## RFI #173: DietEx - Reroute Existing Water Line

**INPATIENT BED EXPANSION**

HCA - LEE'S SUMMIT MEDICAL CENTER  
 2100 SE BLUE PKWY  
 LEE'S SUMMIT, MO 64063

C4.2

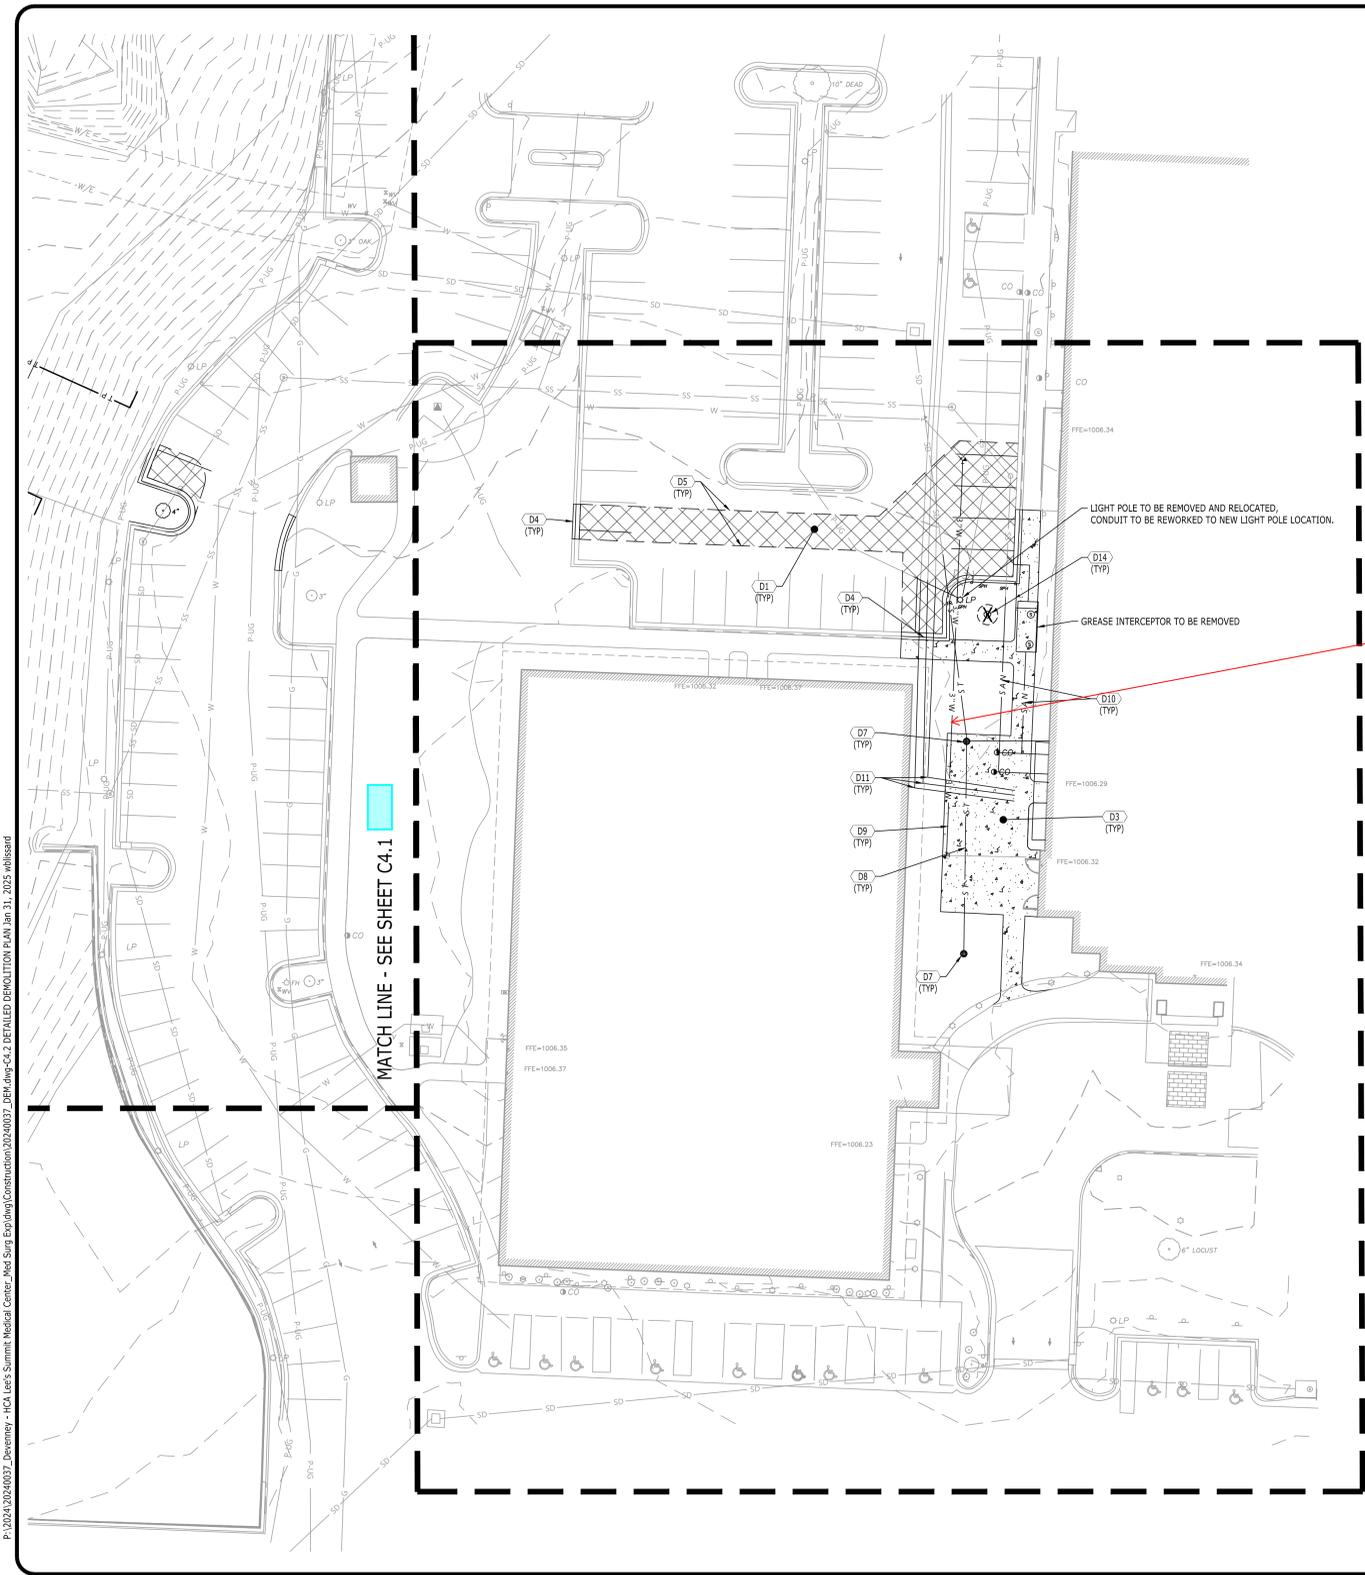
Is it acceptable to leave the existing water line in place and not reroute?

Drawing C4.2 calls for us to reroute the existing domestic water line that runs to the building. After our hydrovac investigation work, we discovered this pipe to be roughly 27.5 feet from the building, and 6 feet below finished floor elevation. It is already outside and below the Dietary Expansion foundation. Is it acceptable to leave in place and not reroute? Please advise.

Domestic Water Line we are called to reroute

**CDG Response: Keeping the existing line in place is acceptable; however, the Structural Team shall confirm there is no issue with the waterline considering the proximity to the structural elements.**

**REFER TO SDL's RESPONSE IN THE RFI DOCUMENT.**  
**SDL: NISHITH SARDHARA**  
**DT: 01/29/2026**

C7.1

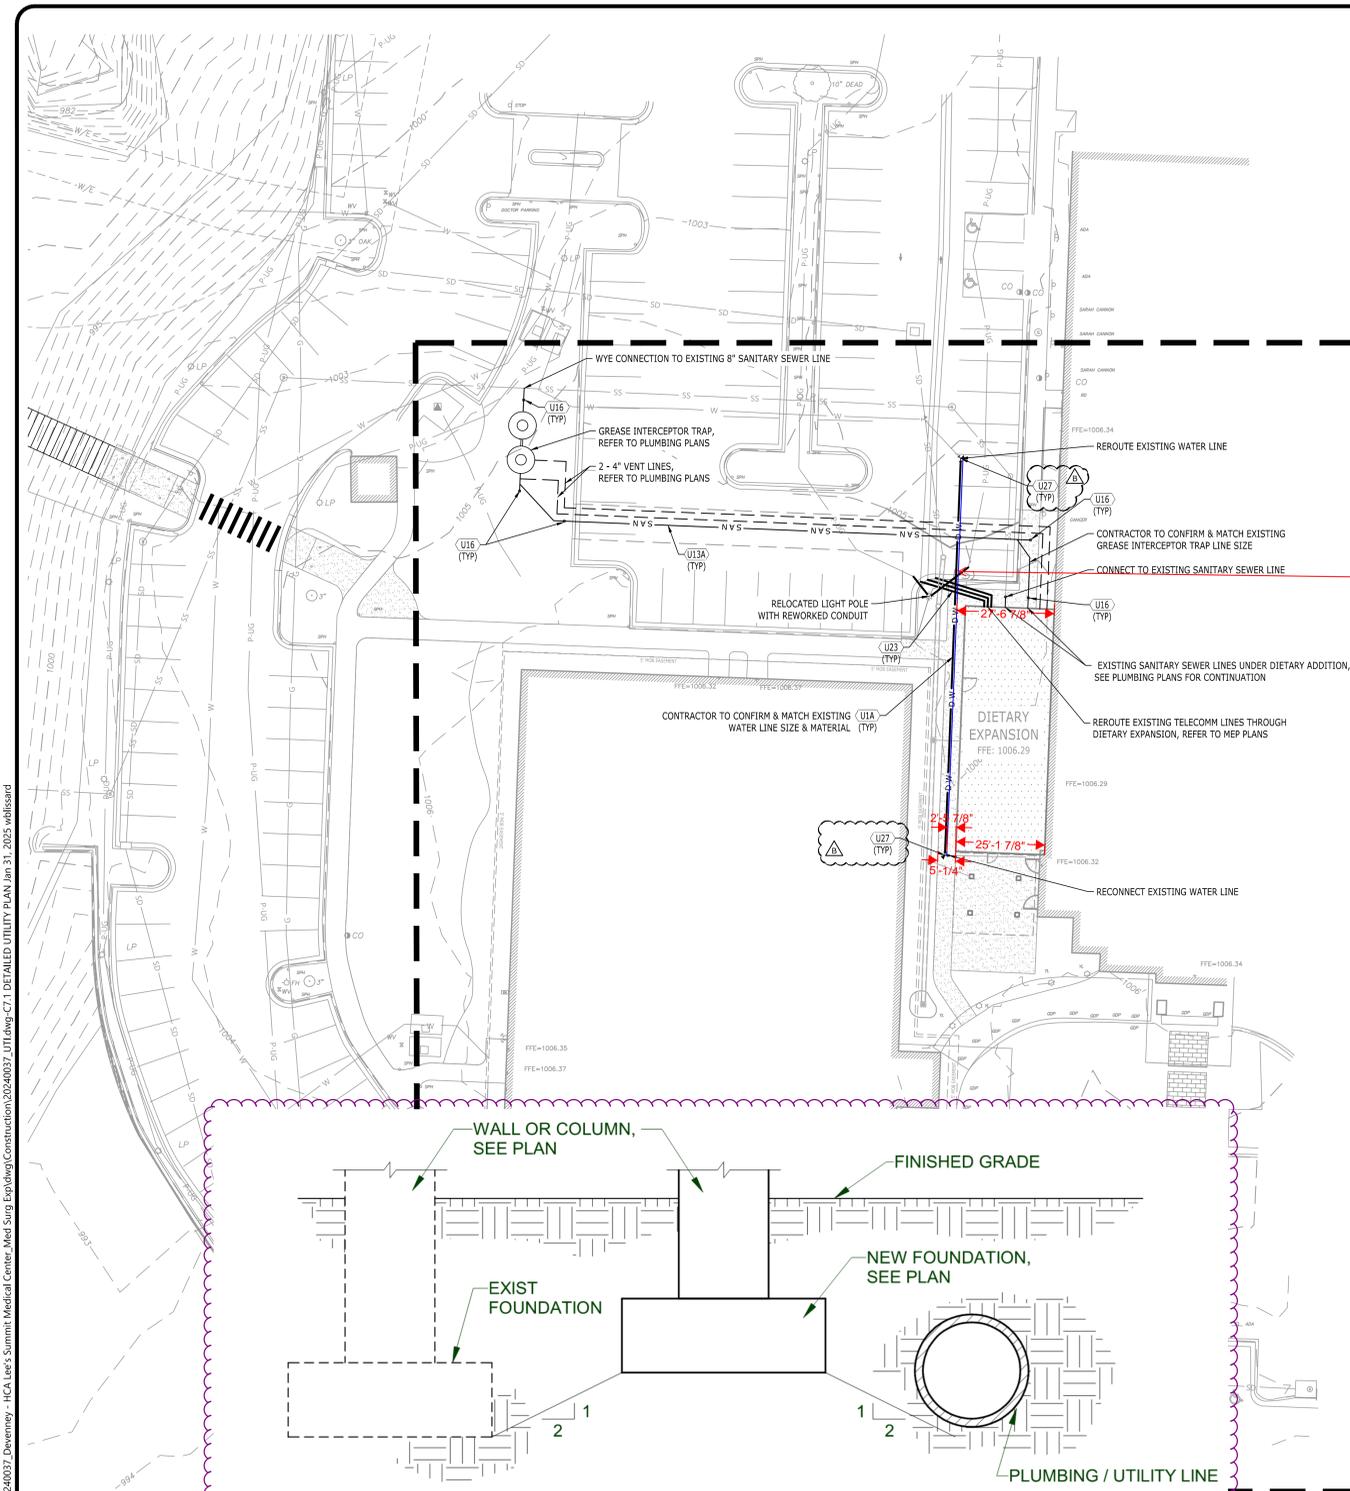
The Domestic Water Line we are called to reroute is located here. It is roughly 27.5 feet from the building and 6 feet below finished floor. It is outside and below the Dietary Expansion foundation. Is it acceptable to leave in place and not reroute?

STRUCTURAL TEAM TO CONFIRM THIS CONDITION IS ACCEPTABLE

To keep the water line as is, The footing needs to drop to follow the attached detail, which would be ~18" per the markups in the RFI. GC to coordinate and confirm the drop of the foundations per the existing conditions.

**1 FOOTINGS ADJACENT TO EXISTING OBJECTS**

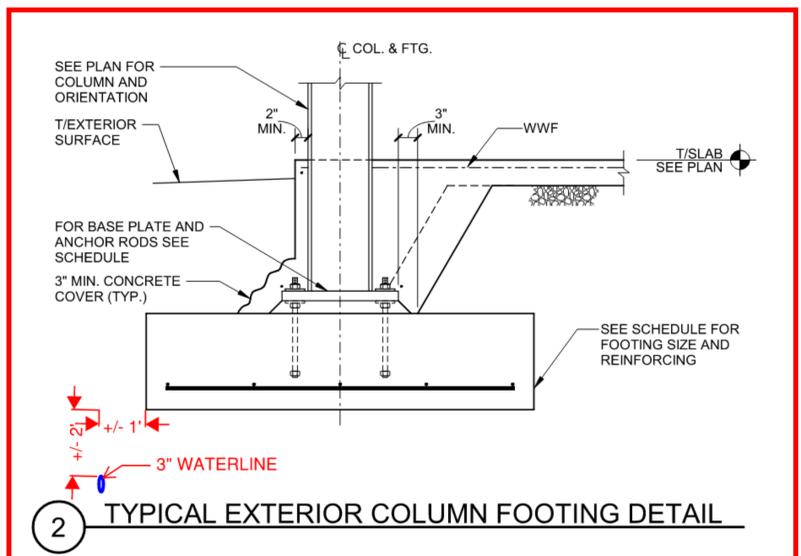
**CONTRACTOR NOTE:**  
 INSTALLATION OF NEW FOOTINGS, PLUMBING LINES, ETC. SHALL BE INSTALLED MEETING THE MINIMUM REQUIREMENTS OF 1 VERTICAL TO 2 HORIZONTAL UNITS WHEN PLACED NEXT TO EXISTING FOUNDATIONS OR PLUMBING LINES AS SHOWN.
